USFAS Compliance Review: Unit 316 Cottage City

Unit 316 Cottage City required alterations

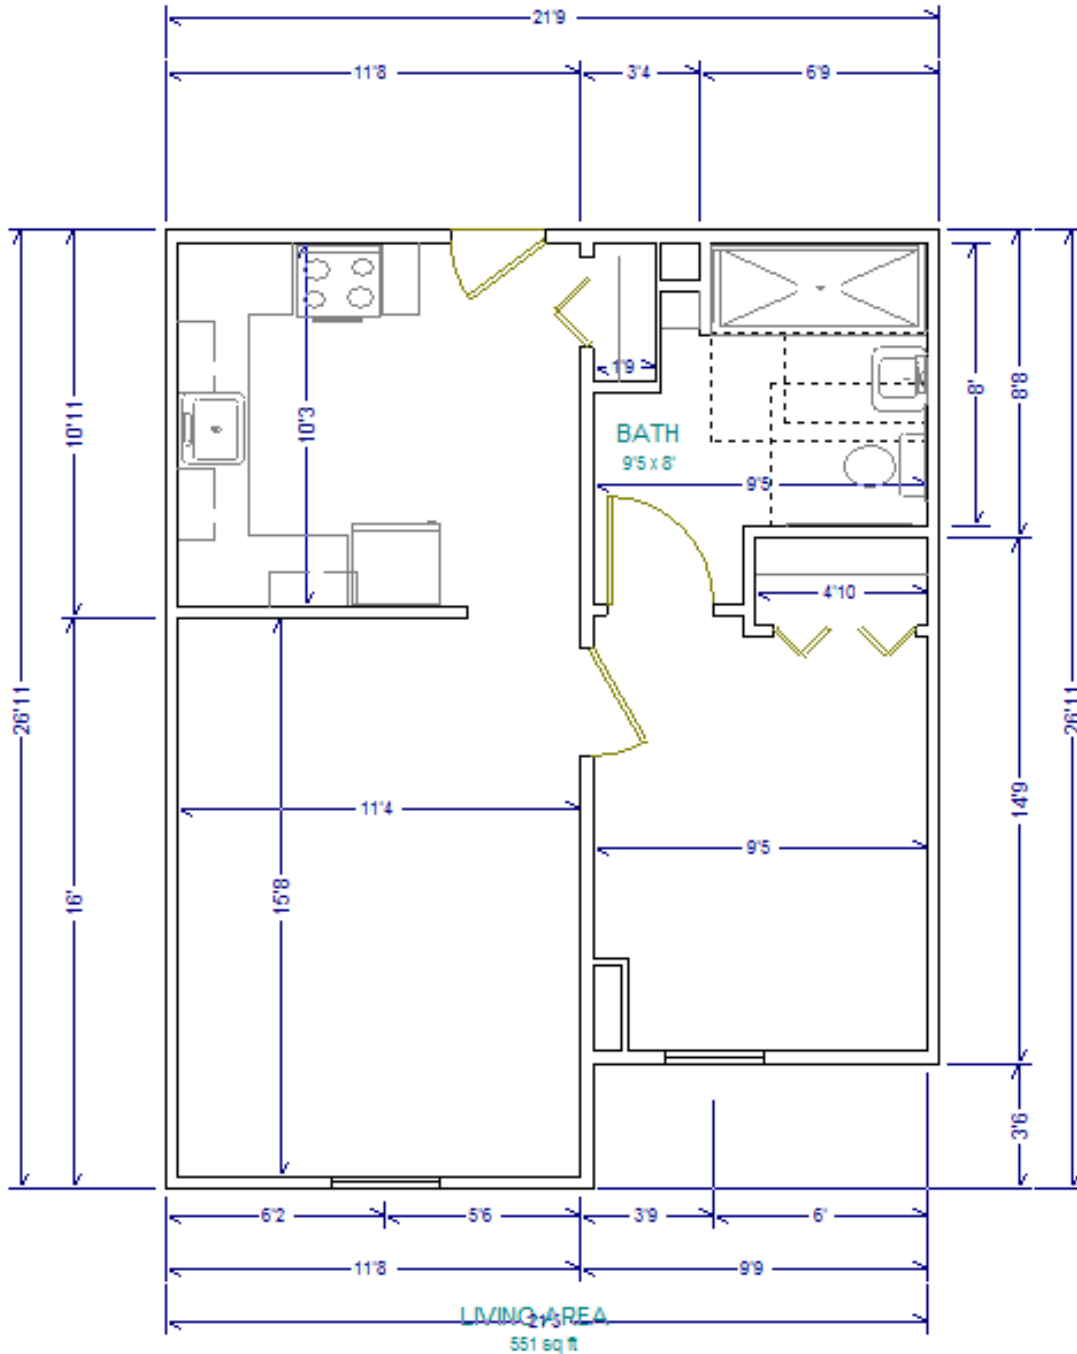
1a -Remove 6' open counter in kitchen to allow for required clearance of 48" at both the stove and sink .
Repair supporting wall and floor as required.

1B -Install additional cabinets in configuration as shown, per plan

1C - Relocate Garbage Disposal switch to face of base cabinet ELECTRICAL

1D - Insulate exposed pipes under sink.

2A – Relocate thermostat and heat convactor controls to a height of 48" ELECTRICAL

3A – Relocate existing wall separating bathroom and bedroom , to allow a distance of 18" clearance from centerline of toilet. Apply ½ " greenboard where appropriate ½" standard sheetrock in all other areas. Relocation of wall will result in the Demo/ retention of bifold doors(2). Steel framing of wall to incorporate 2x6 blocking centered at 36" AFF to accommodate grab bars in bathroom.green gree

Demo, retain and relocate existing 36" interior door and the construction of new closet as per plan.

3B- Install closet rod at Max 54" AFF, and a continuous shelf at a height of max. 56" AFF., within Proposed closet .

3C – relocate, reframe and install bi-fold doors at closet entry.

4A - Relocate existing bathroom light switch 48" AFF on sidewall of bathroom.

4B- Remove existing accessory switch and Non-compliant outlet. **ELECTRICAL**

4C - Construct new wall to define the hall closet space

4D - Repair and replace ceramic tile flooring, remove tile as required to complete pattern.

4E - Repair and replace vct tile flooring, remove tile as required to complete pattern.

4E - Replace and Install marble threshold. **no higher than ½ "**

4 F- Repair and patch paint all affect walls of construction area.

4G-**PLUMBING** Relocate shower control handle to the max. Height of 48" AFF **PLUMBING**

4H Relocate Bathroom cabinet a usable shelf no higher than 44 in (1120 mm) above the floor.

4I insulate exposed pipes under Sink

Citation : UFAS 4.34.6.2 CLEAR FLOOR SPACE A clear floor space at least 30 in by 48 in (760 mm by 1220 mm) complying with 4.2.4 that allows either a forward or a parallel approach by a person in a wheelchair shall be provided at all appliances in the kitchen, including the range or cooktop, oven, refrigerator/freezer, dishwasher, and trash compactor. Laundry equipment located in the kitchen shall comply with 4.34

Citation : UFAS (4.34.6.5* SINK.

The sink and surrounding counter shall comply with the following requirements (see Fig. 51): 1) The sink and surrounding counter shall be mounted at a maximum height of 34 in (865 mm) above the floor, measured from the floor to the top of the counter surface, or shall be adjustable or replaceable as a unit to provide alternative heights of **28 in, 32 in, and 36 in** (710 mm, 815 mm, and 915 mm), measured from the floor to the top of the counter surface or sink rim. The total width of sink and counter area shall be 30 in (760 mm).

Citation : UFAS 4.19.4 EXPOSED PIPES AND SURFACES.

Citation : UFAS A4.27 CONTROLS AND OPERATING MECHANISMS.

Citation : UFAS 4.16.2 CLEAR FLOOR SPACE

Citation : UFAS 4.34.2 Clear Door Width is at least 32" (Measured from the door face to the opposite stop when the door is open 90°.

Citation : UFAS 4.25.3 HEIGHT.

Citation : UFAS 4.22.3 CLEAR FLOOR SPACE. The accessible fixtures and controls required in 4.22.4, 4.22.5, 4.22.6, and 4.22.7 shall be on an accessible route. An unobstructed turning space complying with 4.2.3 shall be provided within an accessible toilet room. The clear floor space at fixtures and controls, the accessible route, and the turning space may overlap. **4.34.5.7 CLEAR FLOOR SPACE.** Clear floor space at fixtures may overlap. **EXCEPTION:** In bathrooms with only one water closet, one lavatory, and one bathtub or shower, a clear floor space of 30 in by 60 in (760 mm by 1525 mm) may be used in lieu of the unobstructed turning space.

Citation : 404.2.5 Theshold , if provided at doorways, shall be 1/2 inch

Citation : UFAS 4.34.5.5 SHOWERS.

Citation : UFAS 4.34.5.3 LAVATORY, MIRRORS, AND MEDICINE CABINETS.

Citation : 4.19.4 EXPOSED PIPES AND SURFACES.

Exhibit B. Clearances

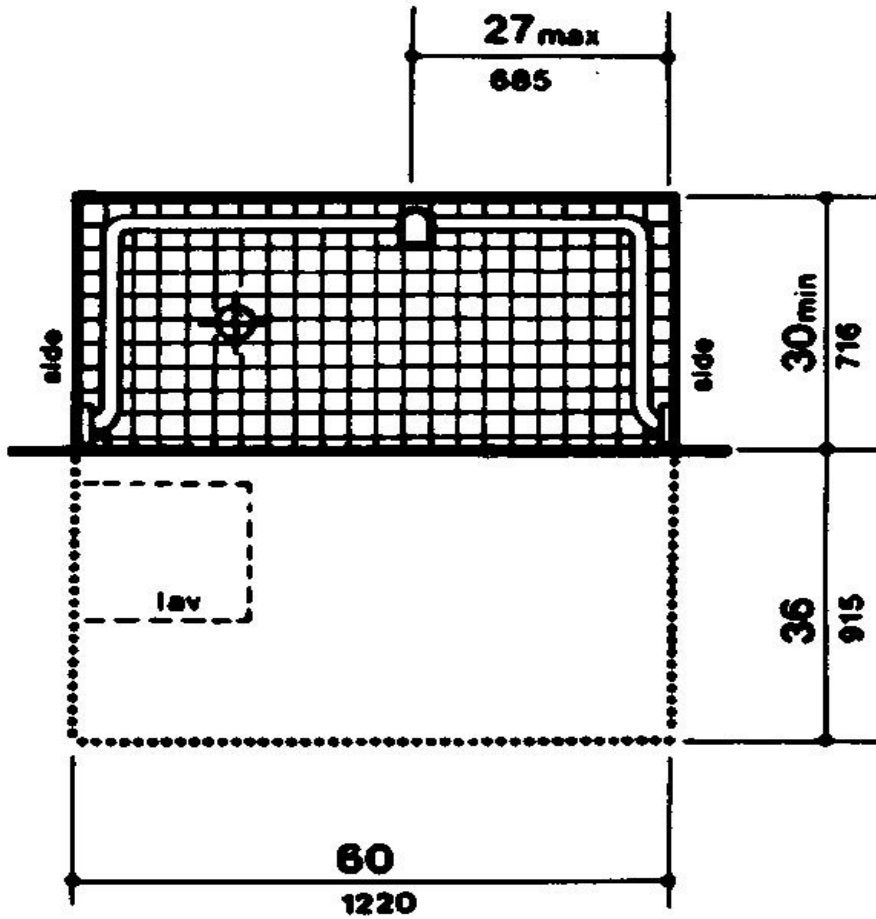
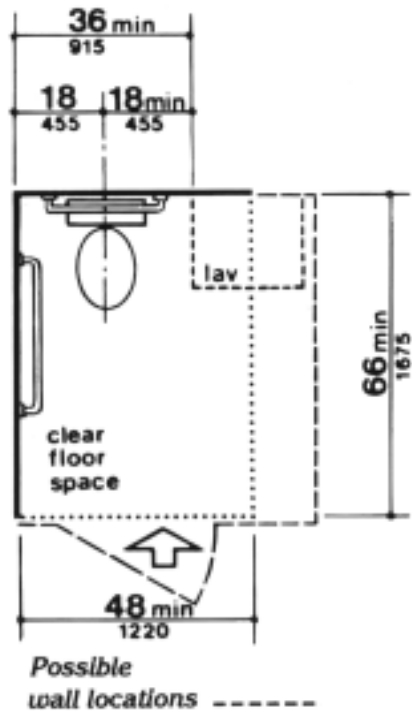
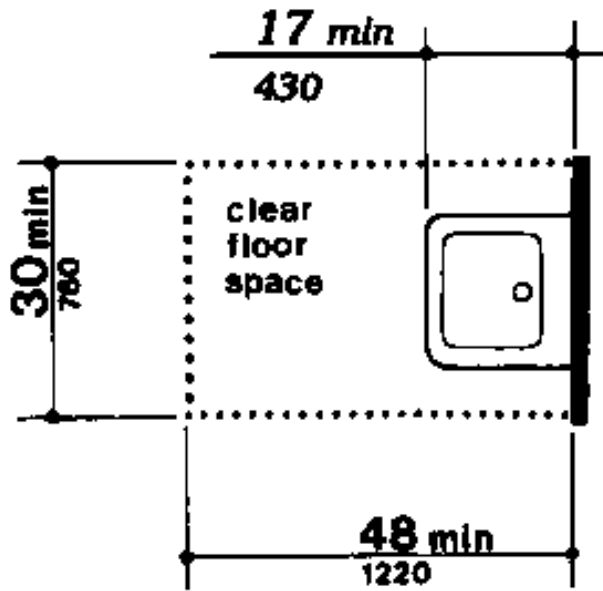
4 Bathroom (See, Exhibit B and C)

4.19.3 CLEAR FLOOR SPACE. A clear floor space 30 in by 48 in (760 mm by 1220 mm) complying with 4.2.4 shall be provided in front of a lavatory to allow forward approach. Such clear floor space shall adjoin or overlap an accessible route and shall extend a maximum of 19 in (485 mm) underneath the lavatory (see Fig. 32).
